STAFF REPORT

TO: ADP **MEETING DATE:** January 10, 2024
FROM: Planner II **FILE NO:** 3220-Gibsons Way-702
SUBJECT: **OCP and Zoning Amendment for a 5-unit residential development at 702 Gibsons Way**

Figure 4: Comparison Site Plan and Elevation with 0.53 FSR and 0.80 FSR

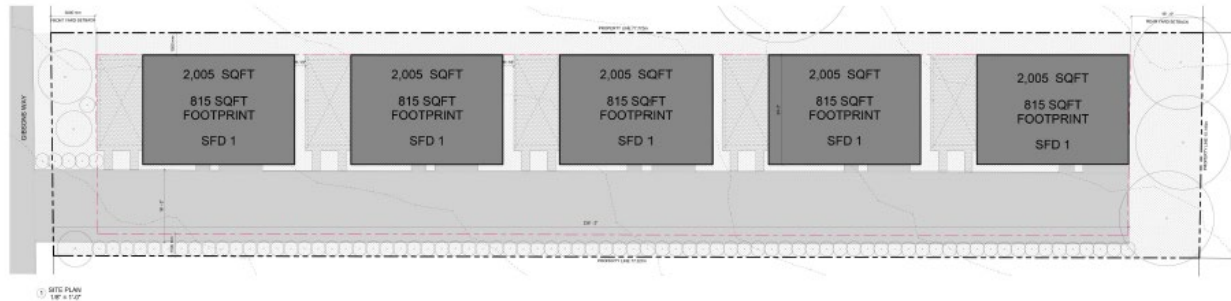
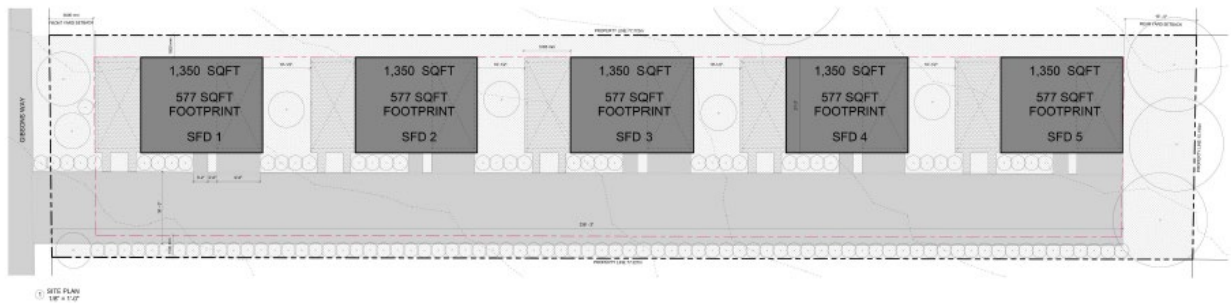
Staff requested the architect to provide a comparison of what the development would look like in the proposal met the 0.80 FSR. The images below show the 0.80 SR compared with the proposed development at 0.53 FSR, as you can see the main difference is size of unit and the reduction of the 3 metre setback between buildings to less than 2 centimetres.
